FSCA Ref: MM-FSA-01

Date: 2020-12-04

Urgent Field Safety Notice
Tourni-Cot Universal – “Uni-Cot”

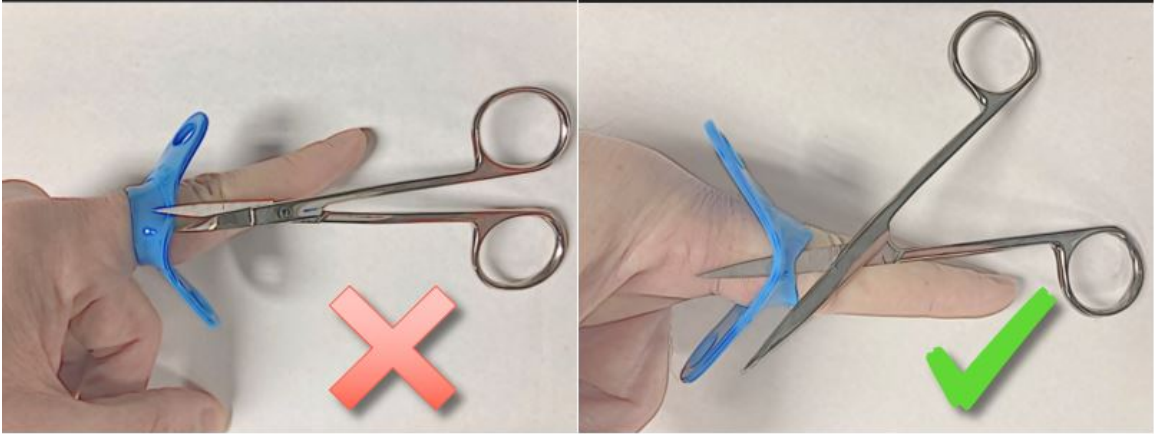
2	7. Other information relevant to FSCA
.	The manufacturer believes that this failure can be largely mitigated by following standard best practices for the use of tourniquets, specifically by reviewing the affected digit for complete removal of device prior to completion of the procedure. See images below for guidance:
	<p>Do not partially snip the edge of the device. Sever the device completely from the digit.</p>
